DOK | 2007 Bridge Inspection Review and Rating | Dec.1st, 2008

Issues in red require immediate attention
Issues in bold black need attention for safety concerns

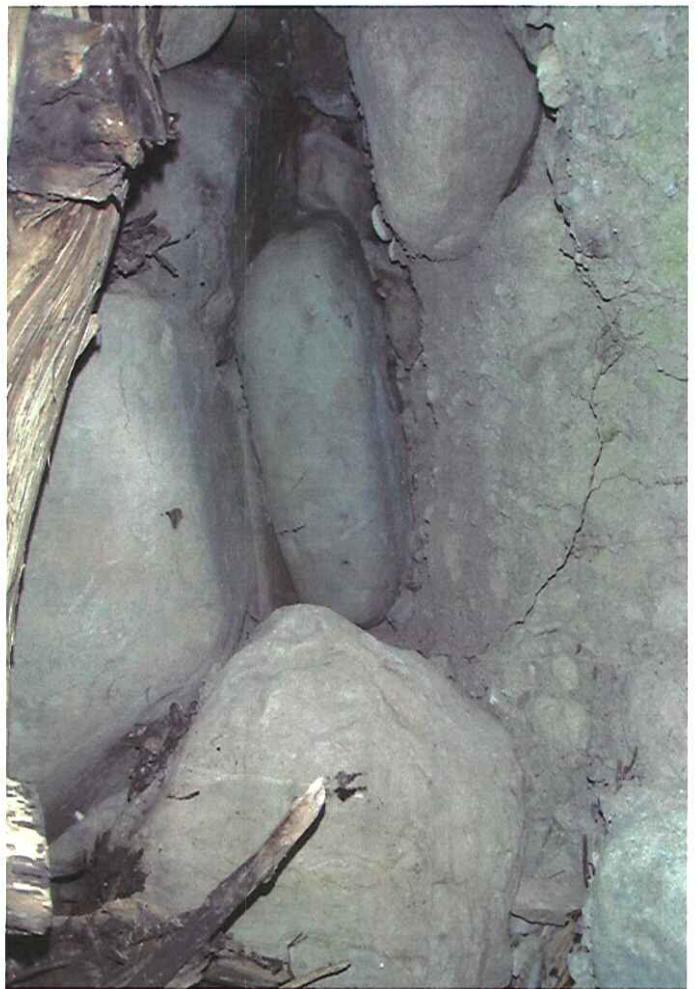
PRESENT LOAD RATING OF 41 TONNES TO CONTINUE, SUBJECT TO CARRYING OUT SCOUR DAMAGE REPAIR.

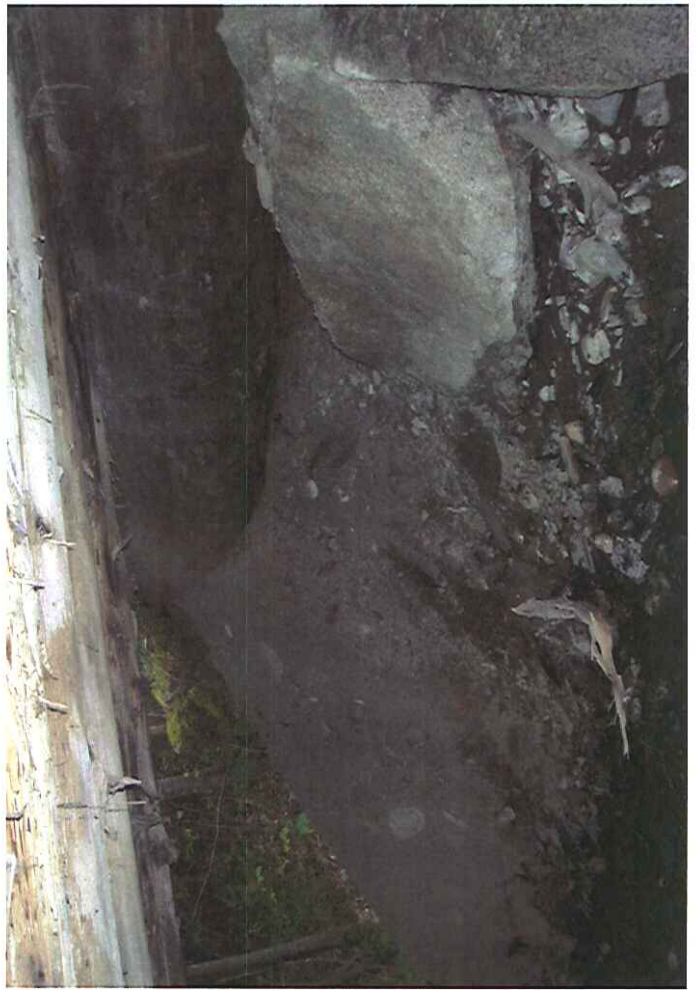
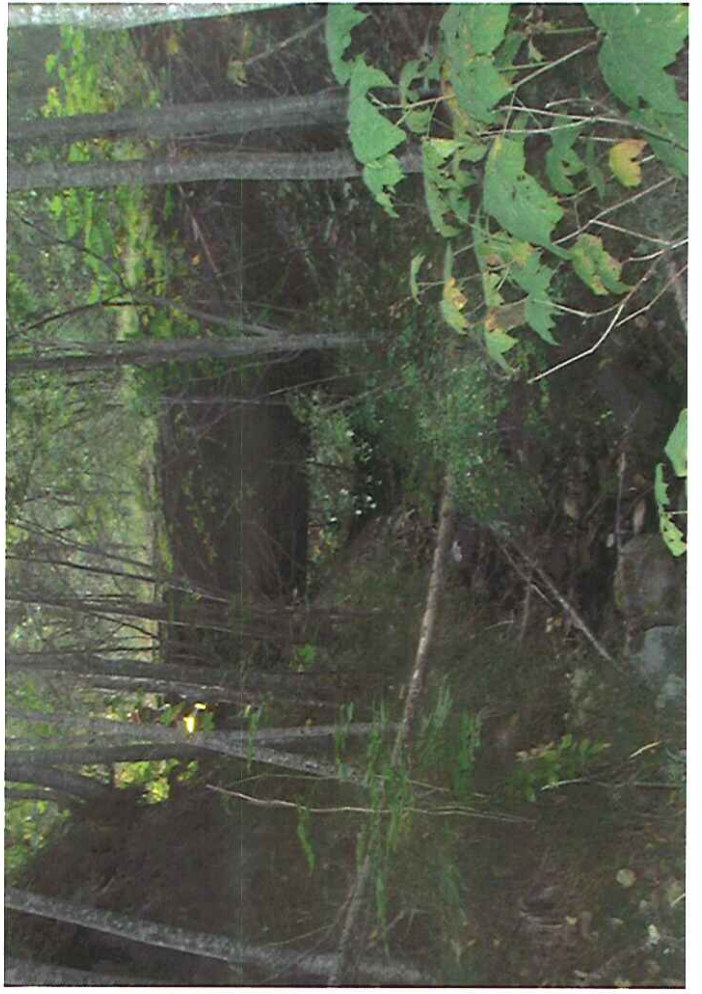
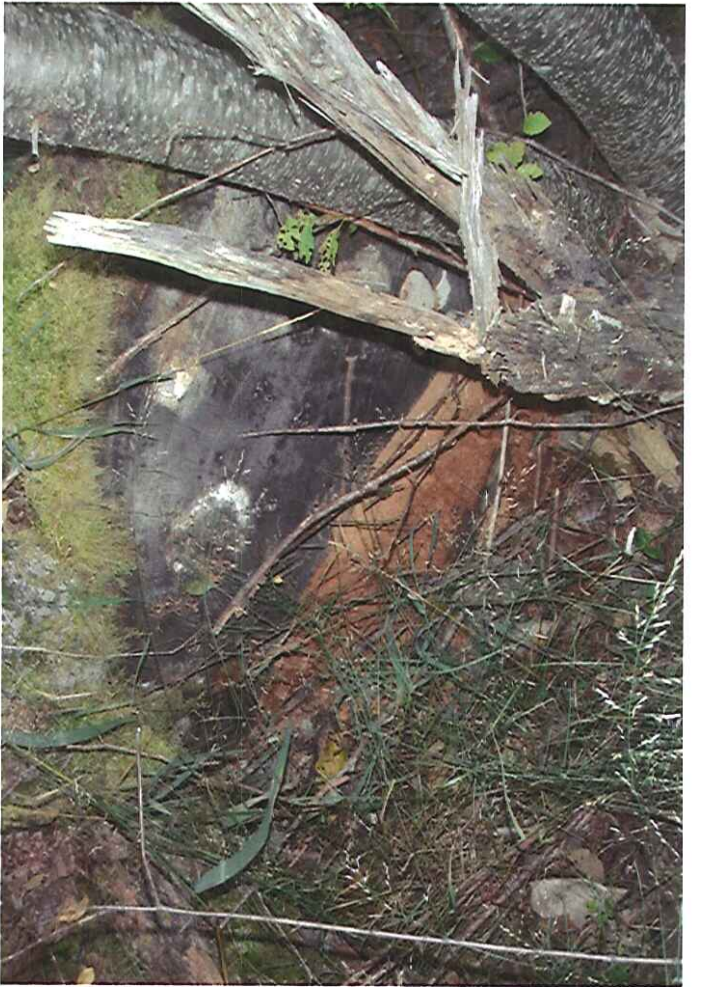
Based on the condition of the sill logs, the overall condition of this structure is poor.
NEW LOAD RATING IS 446 OR 41 TONNES, SUBJECT TO REPLACING SILL LOGS, AND STRINGER #1.

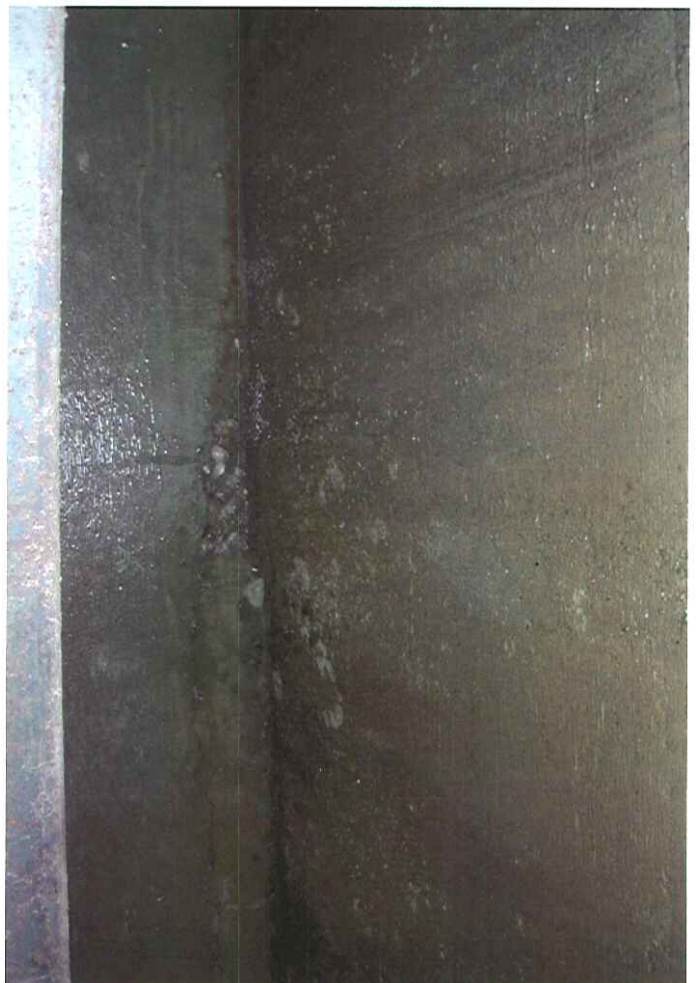
PRESENT LOAD RATING OF 175 OR 68 TONNES TO CONTINUE.

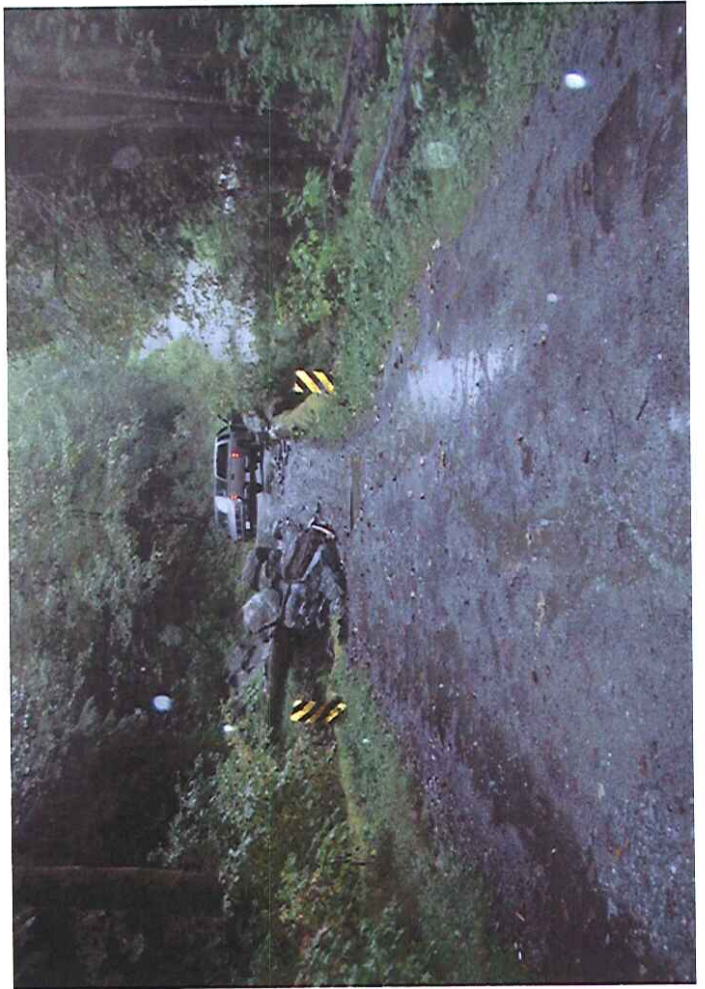
REPLACE TIES AND DECK TO ATTAIN LOAD RATING OF 6.6 OR 5.4 TONNES. UNTIL THEN, POST NEW RATING OF 10 TONNES. ADVISE ALL USERS.

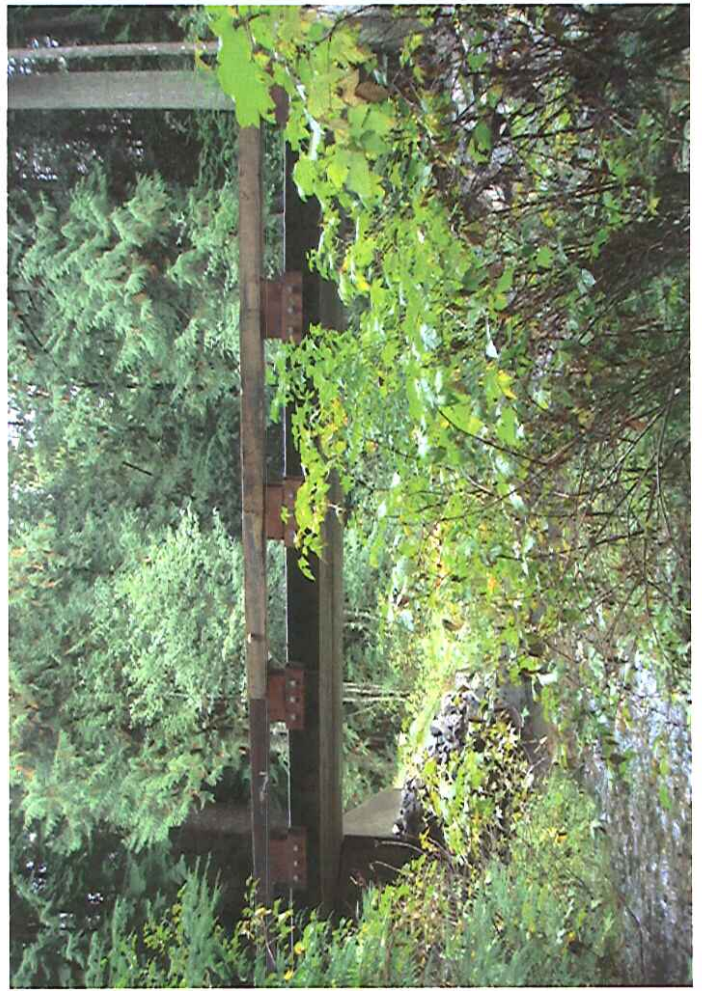
PREVENT LOAD RATING OF LGS OF 54 TONNES TO CONTINUE.

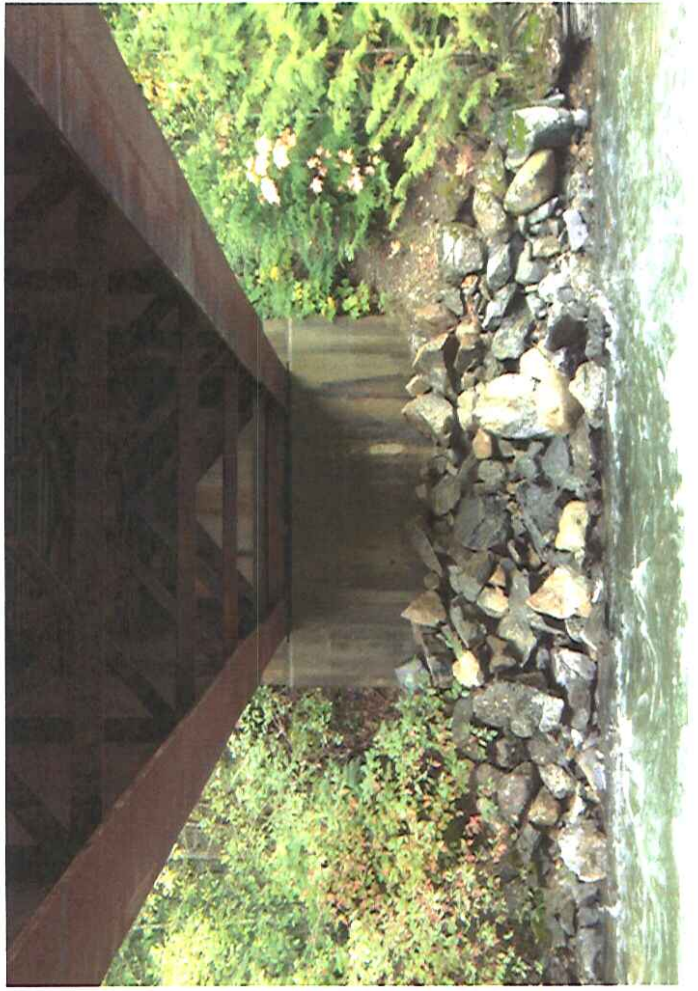
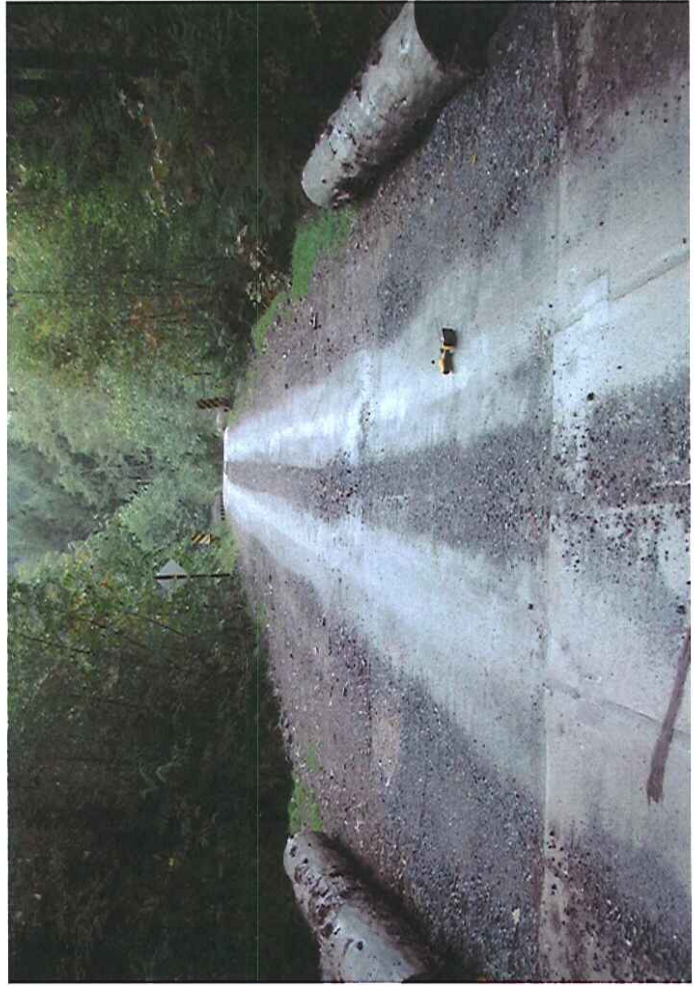
The overall condition of the structure is fair. Consider installing narrow structure signs at approaches.

RETAIN PRESENT LOAD RATING OF 1100 OR 91 TONNES.

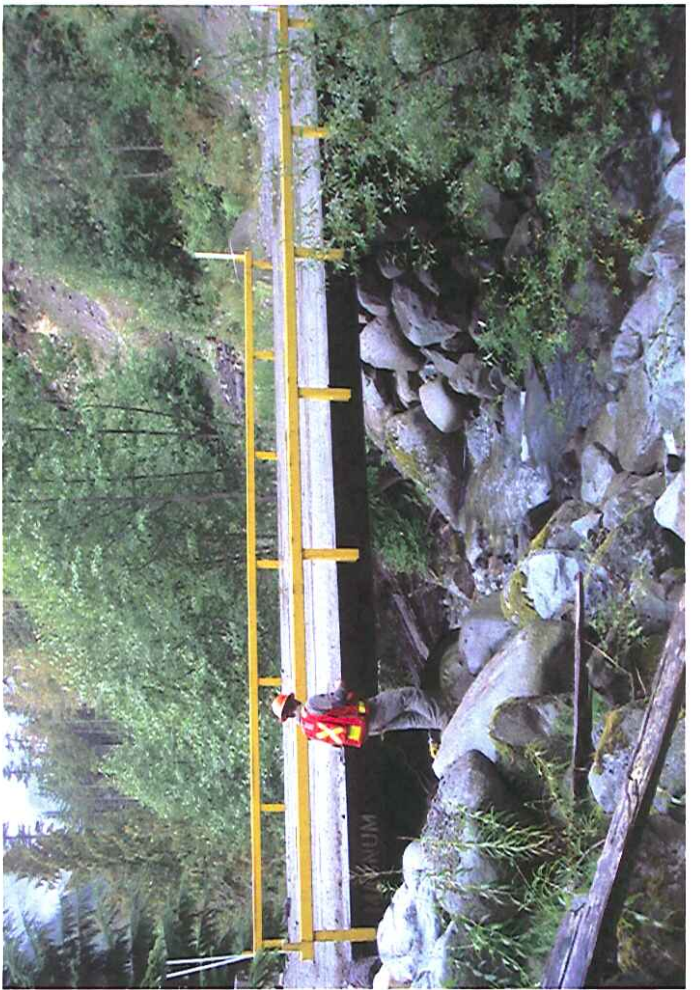
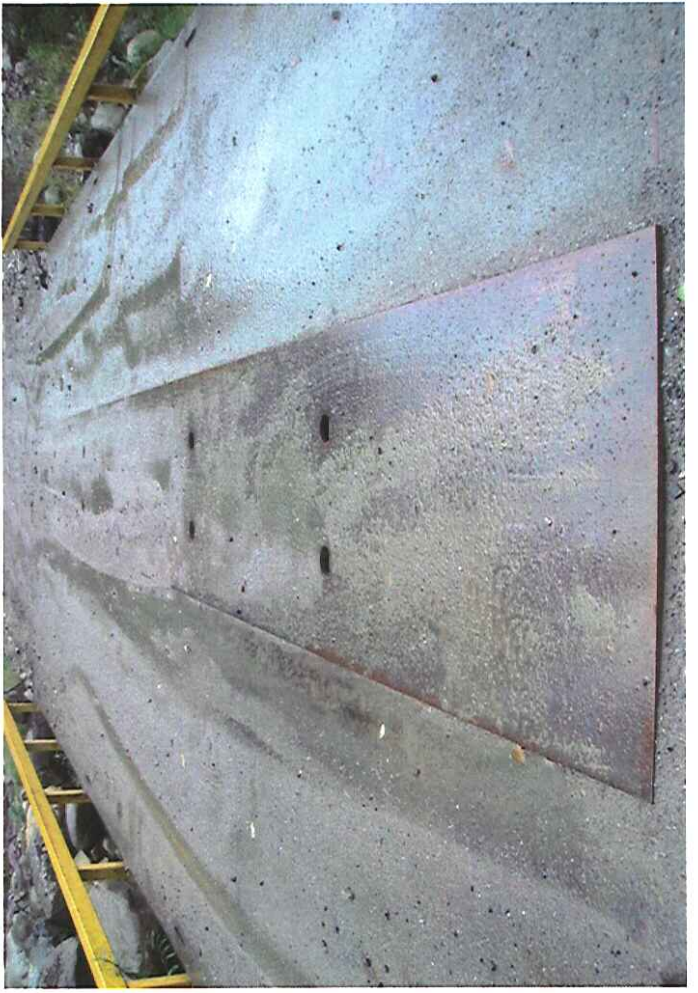
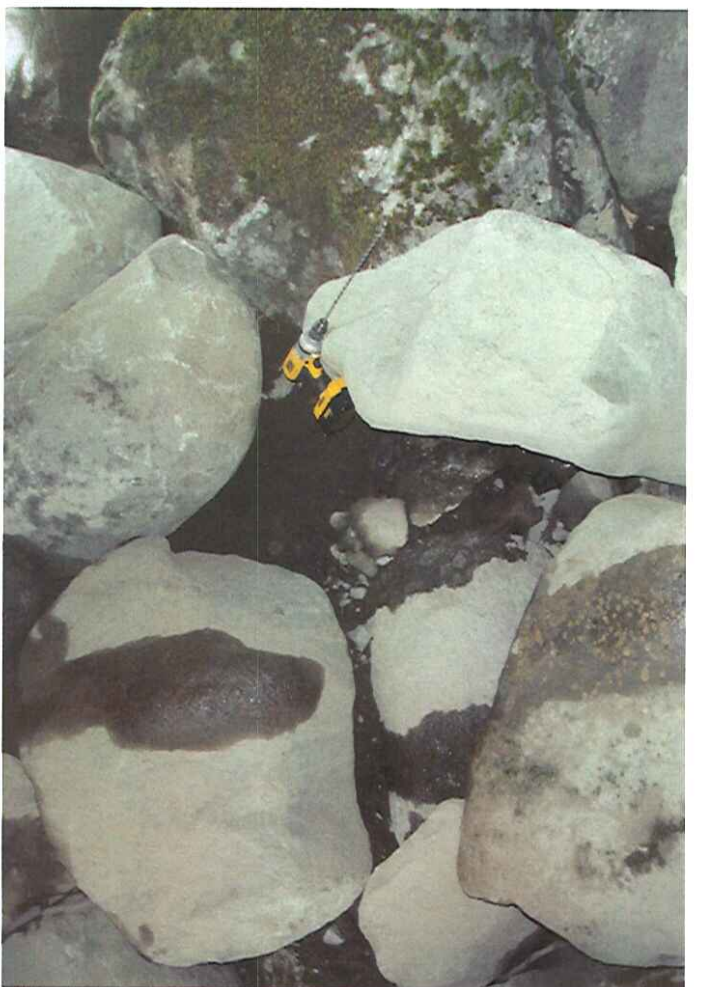
The overall condition of the structure is fair. Consider installing narrow structure signs at approaches. Monitor town side abutment.

PRESENT RATING OF 150 OR 150 TONNES TO CONTINUE. (THIS RATING APPLIES TO ALL STEEL PORTABLE STRUCTURE)

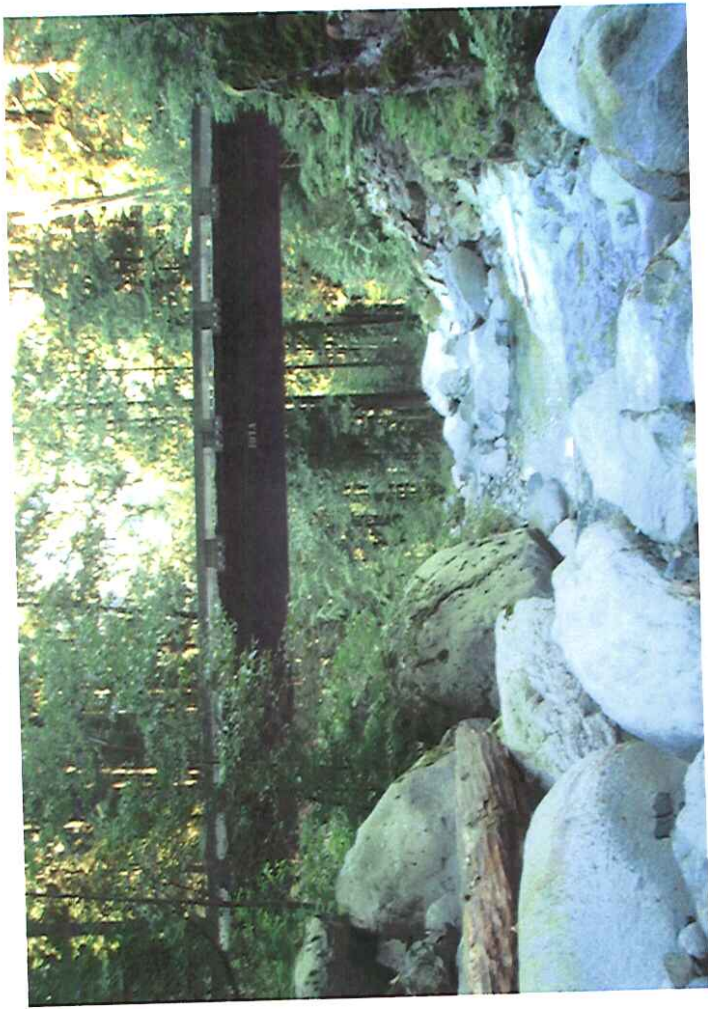
The overall condition of the structure is fair. Consider installing narrow structure signs at approaches.

PREVENT LOAD RATING OF L75 OR 68 TONNES TO CONTINUE.

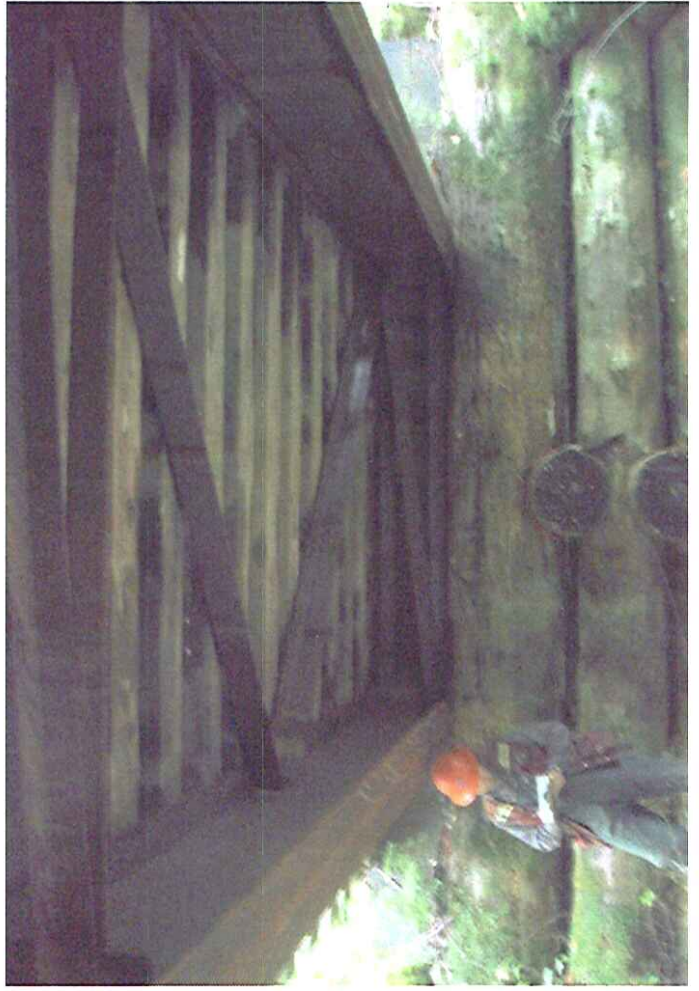
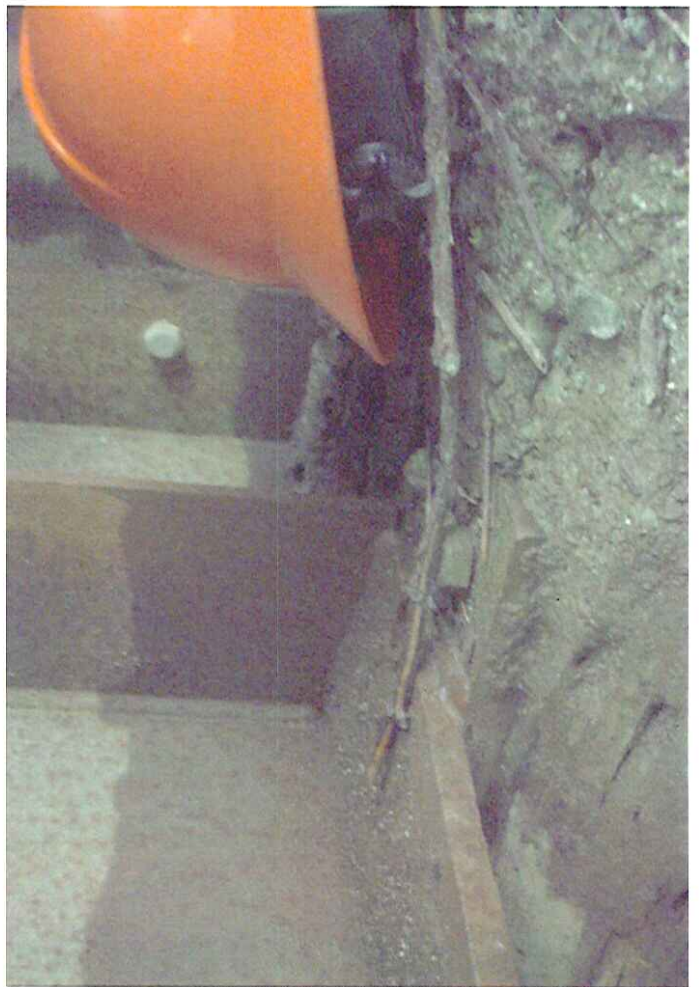
Due to the condition of the curb, deck, and ties the overall condition of this structure is poor.

Post New Load Rating of 5 tonnes. Advise all users. Replace deck and ties to attain original ratings. Refer to AS-BUILTS.

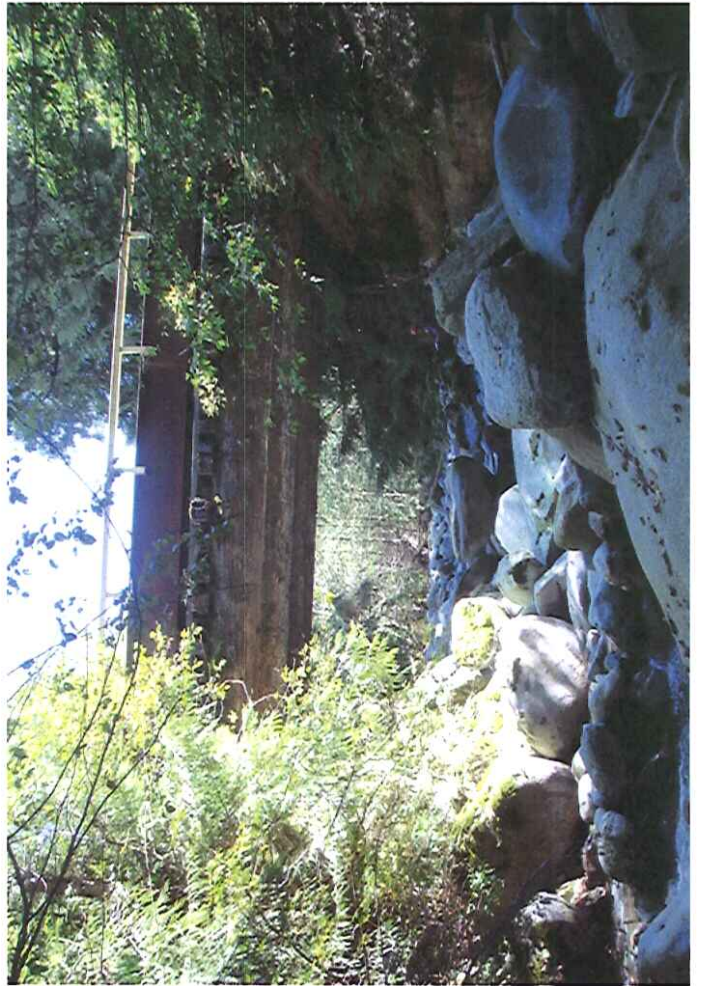
The existing structure has been over spanned with an all-steel portable to limit the live load surcharge on the existing cribs. Based on the condition of the all-steel portable and cribs the overall condition of this structure is fair.

RETAIN PRESENT RATING OF 1.15 OR 60 TONNES. (ALL STEEL PORTABLE).
